KWM-380 TRANSCEIVER (622-5093-101)
HF-380 TRANSCEIVER (622-3580-101)
RECEIVER-EXCITER CIRCUIT CARD A3 (638-6908-001)

SERVICE BULLETIN NO 1**PRODUCT IMPROVEMENT**

This is a nonmandatory service bulletin which applies to the following:

P/O Receiver-Exciter Circuit Card A3.
Figure 1 (Sheet 2)

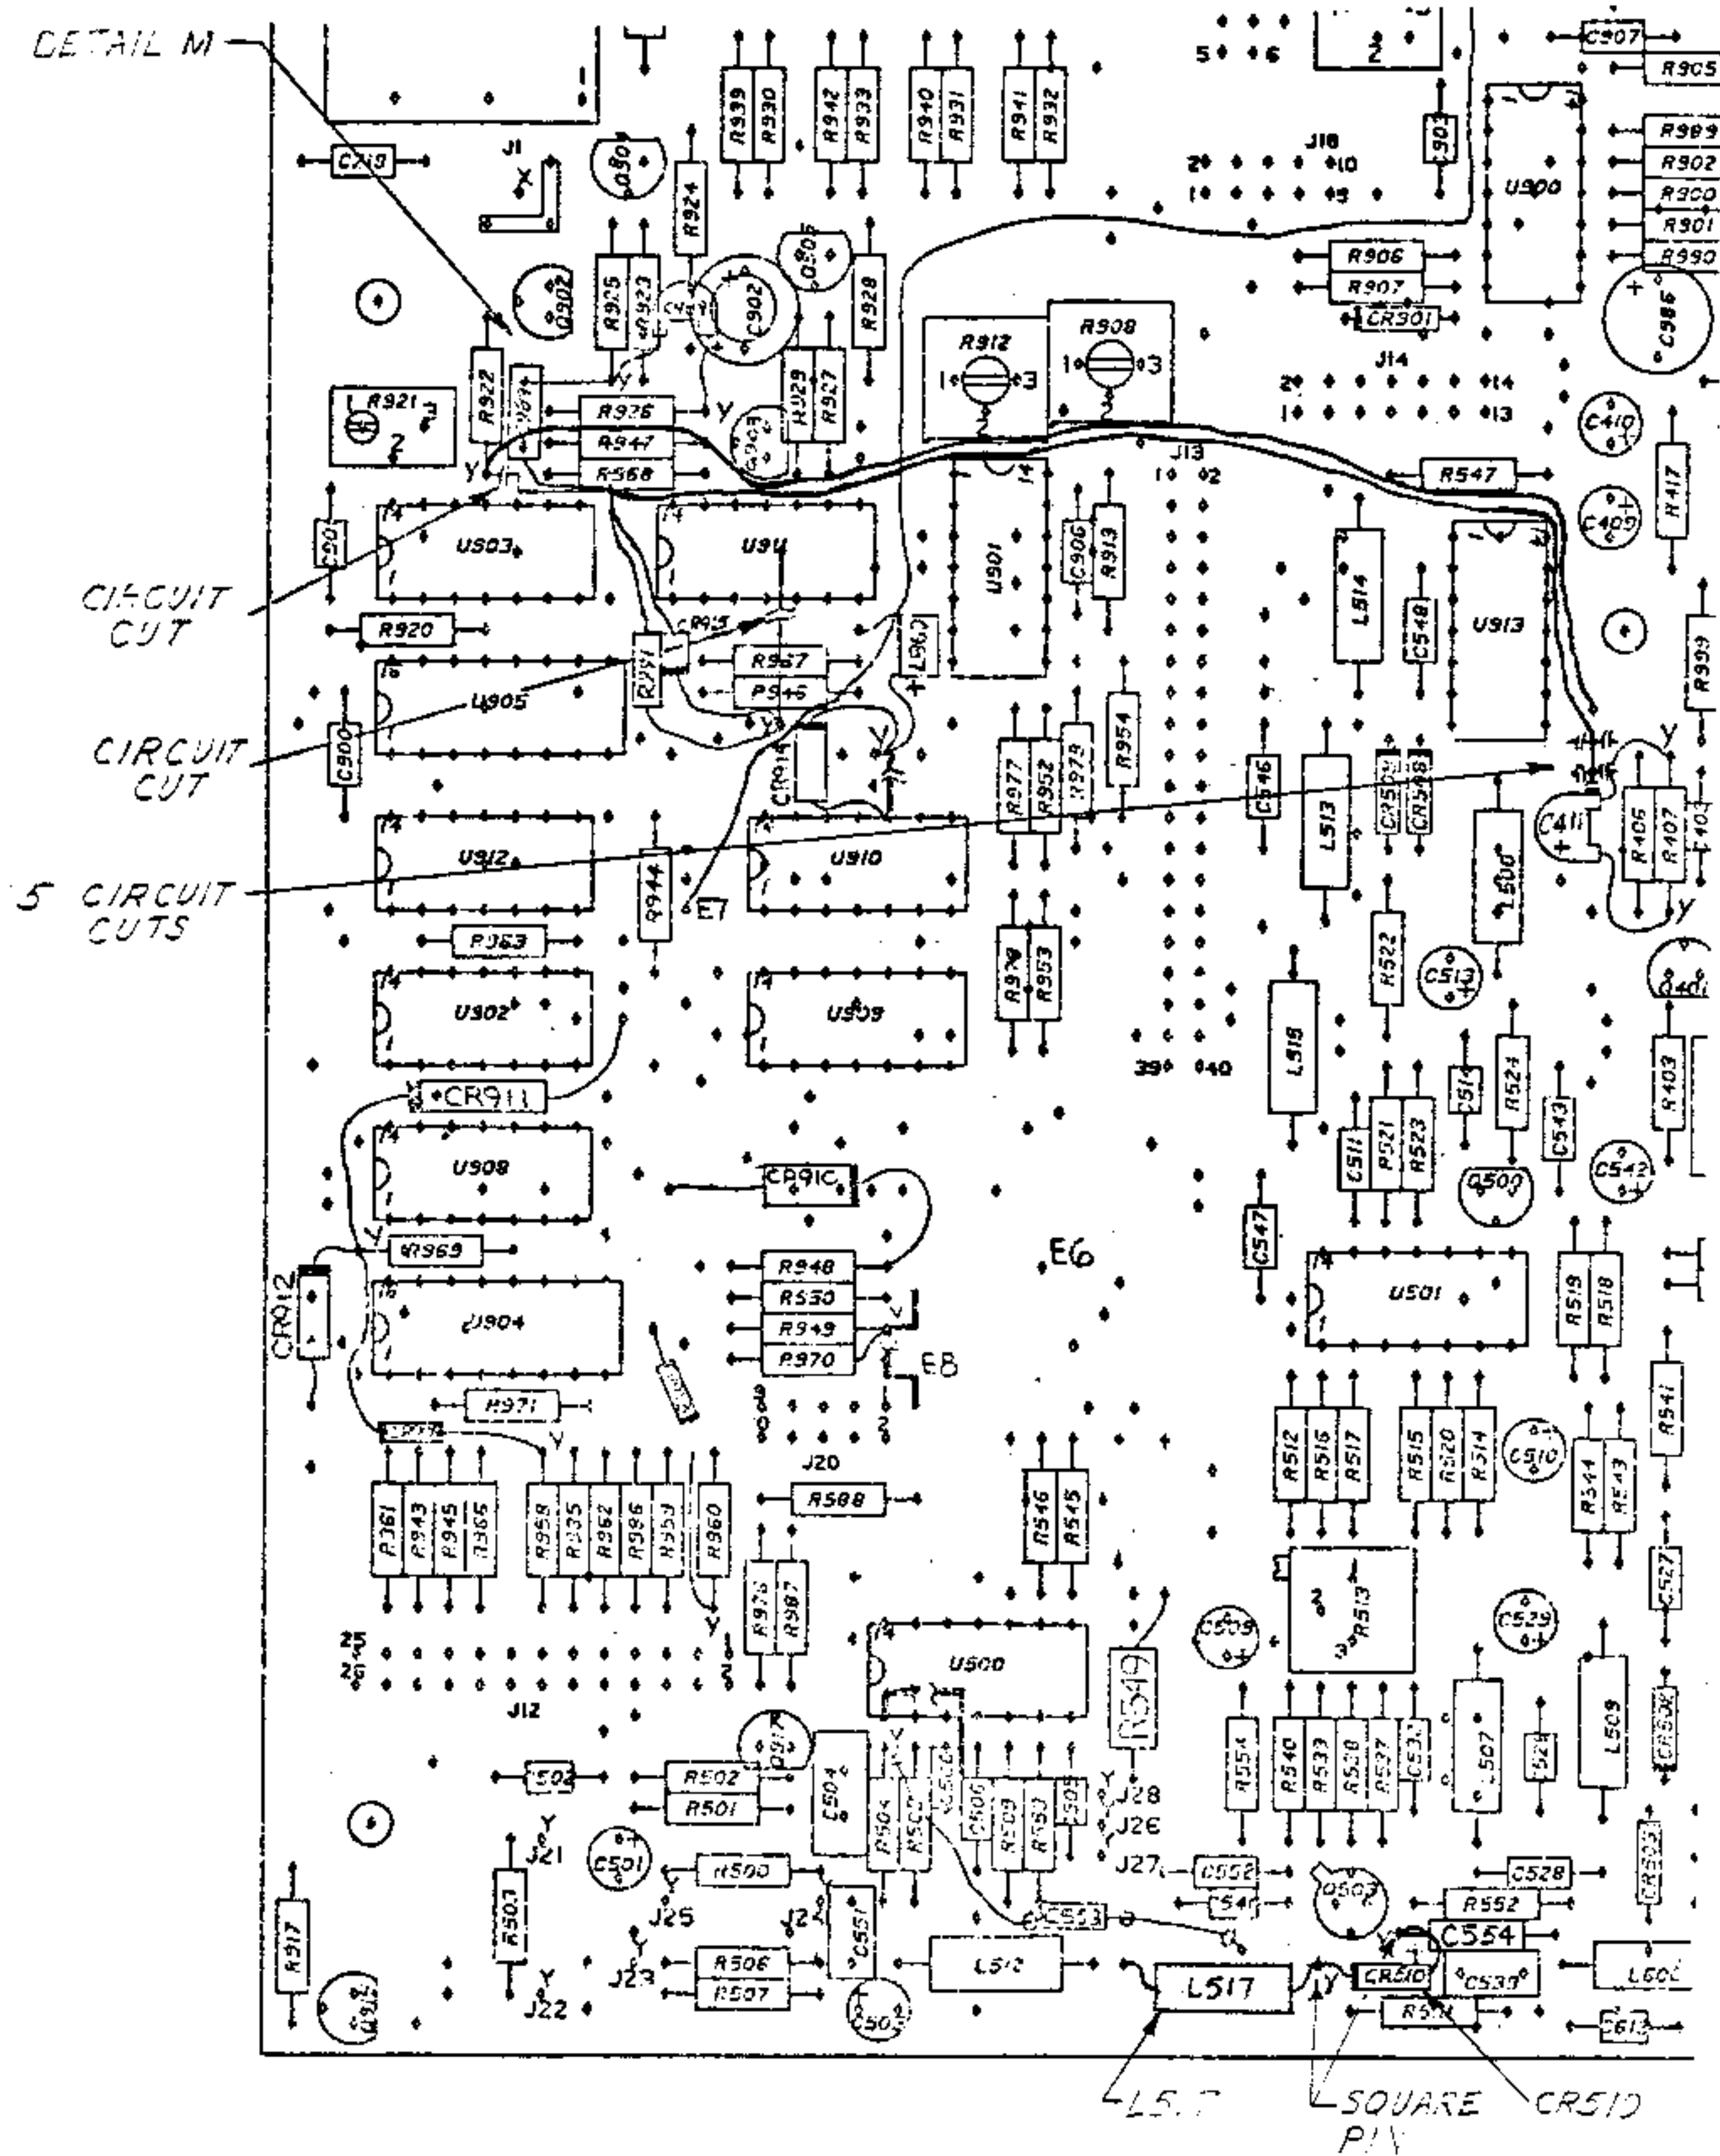
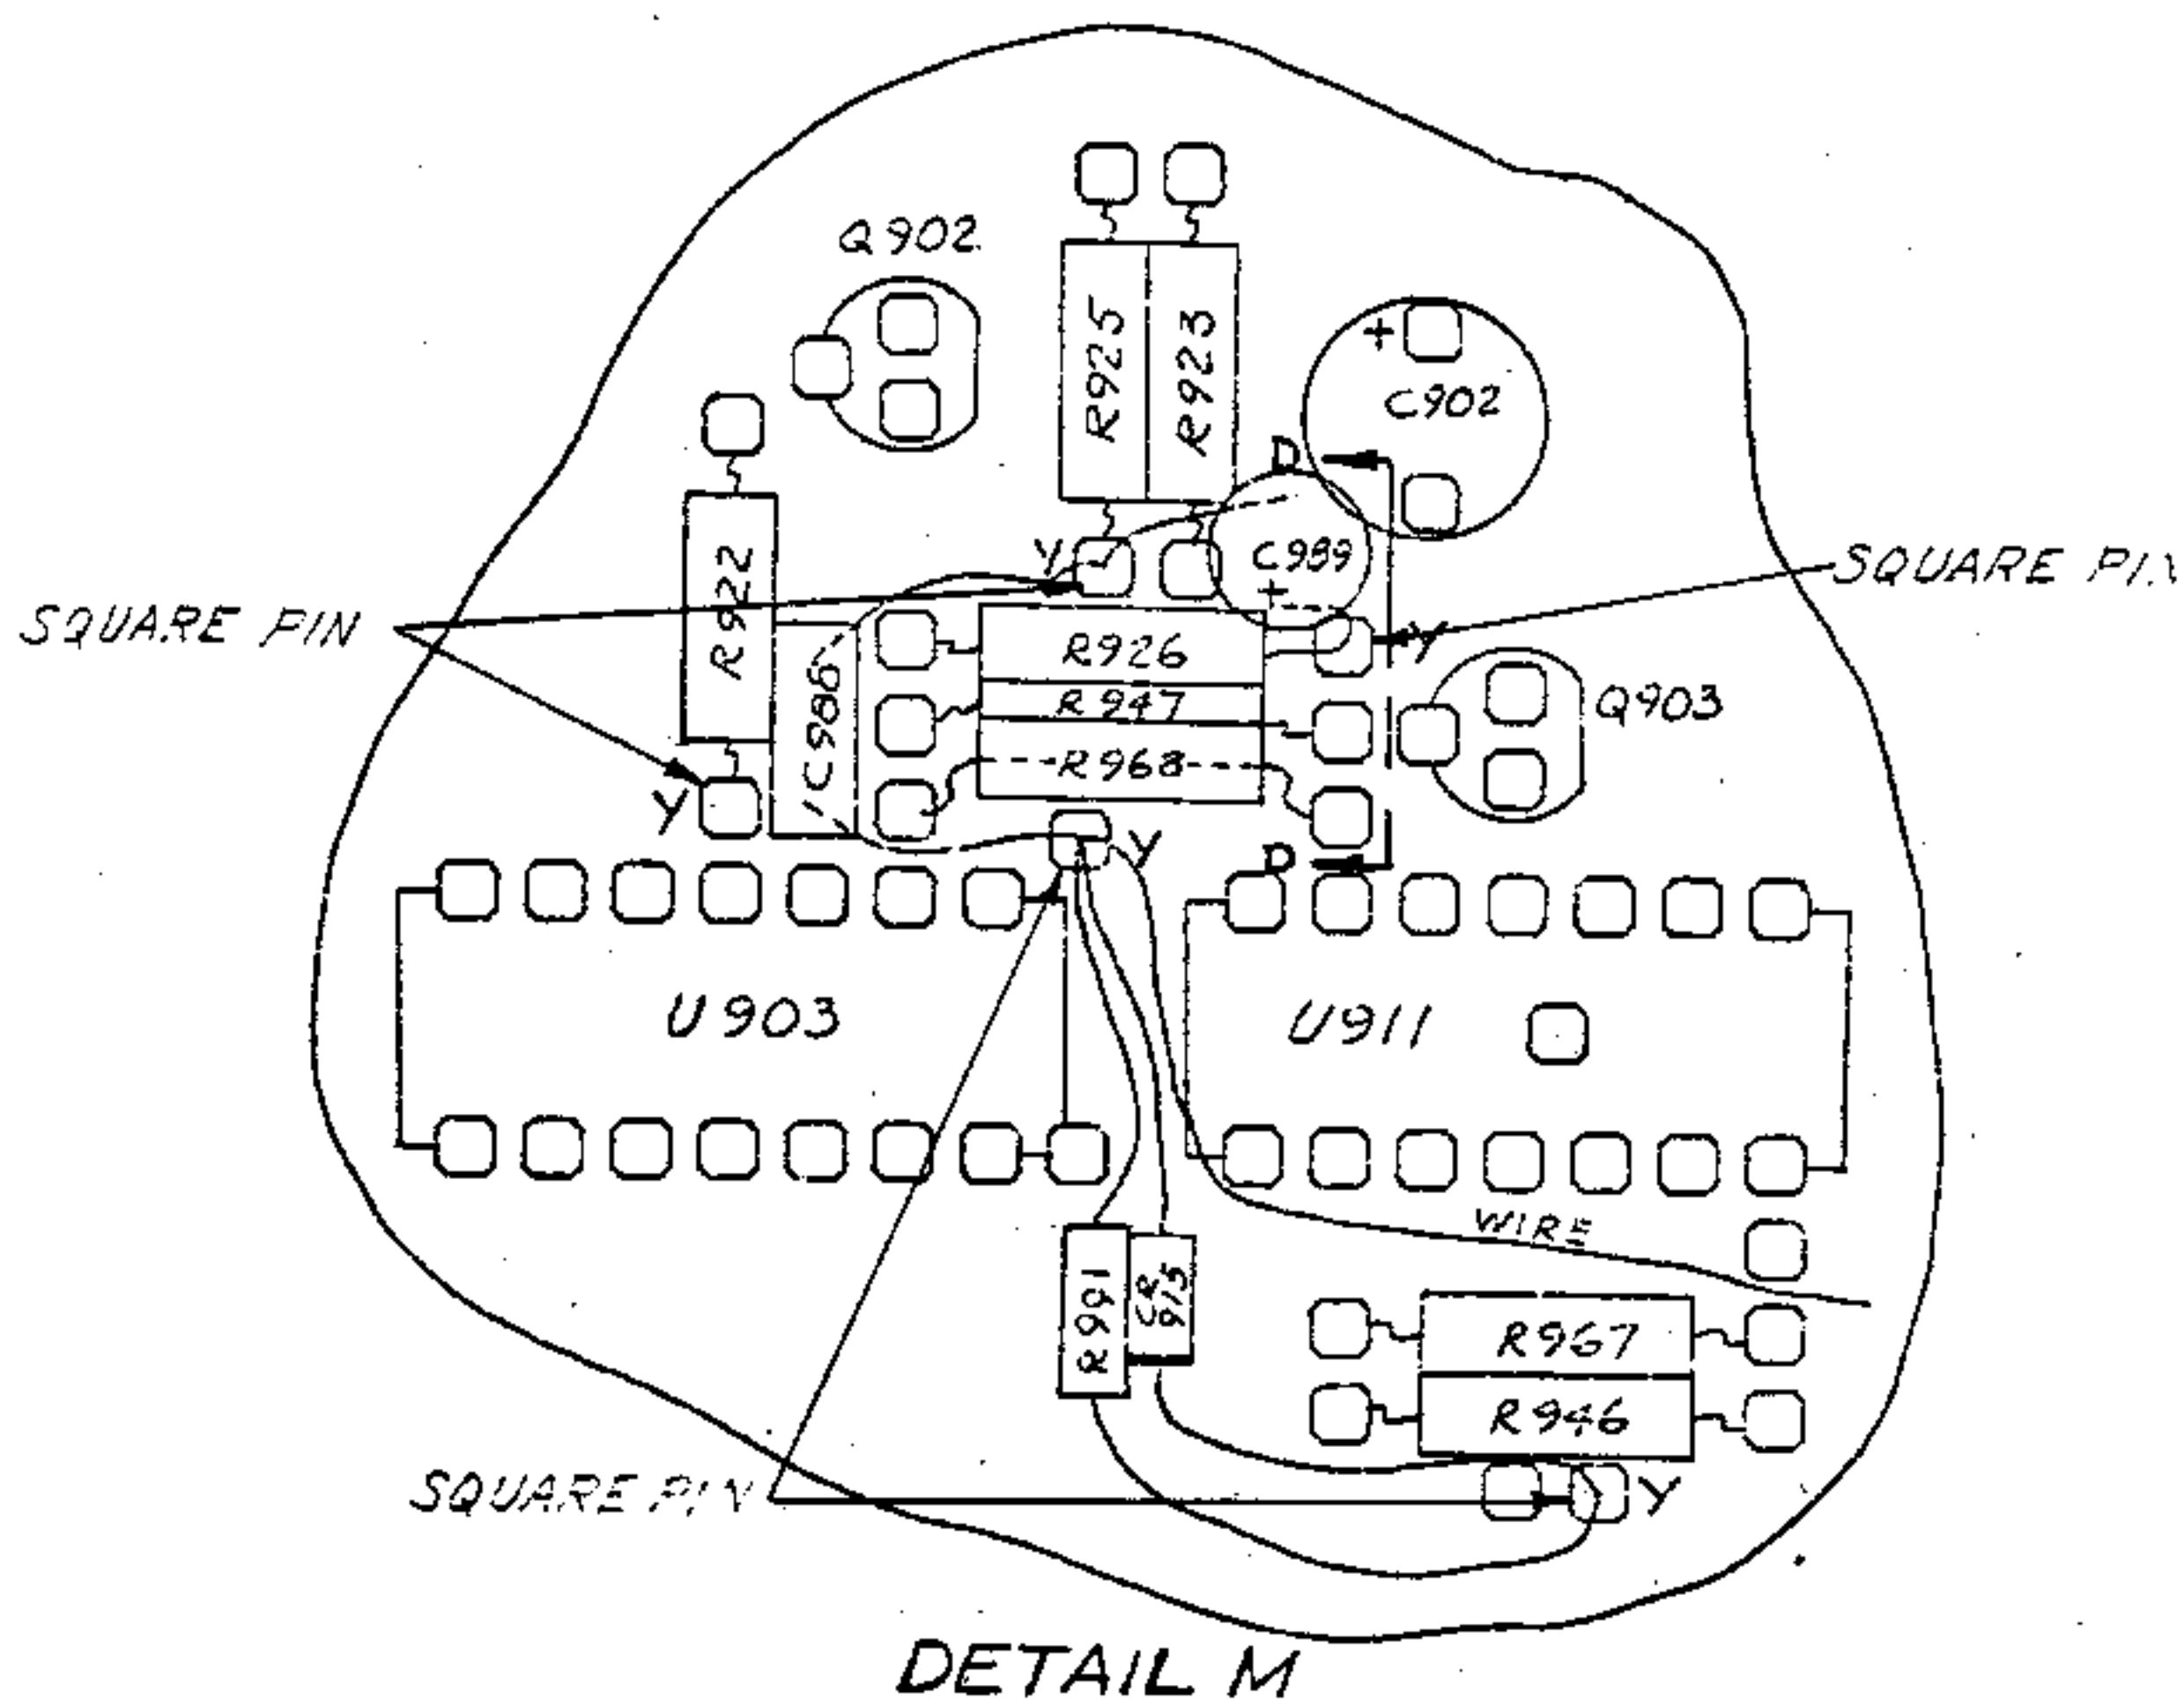
- H. Refer to figure 1, detail M, for location and install five square pins (372-2601-045). Lift component leads, as necessary, and reconnect the leads to the pins after the square pins are installed.

- N. Install 0.1- μ F capacitor C988 (913-5019-440) from the square pin at the bottom lead of R925 to the square pin below R968.
- O. Install 1.5- μ F capacitor C989 (184-9102-800) with the positive lead connected to the square pin at the right-hand lead of R926 and the other lead connected to the square pin at the bottom of R925. Refer to figure 1, detail M, section D-D.
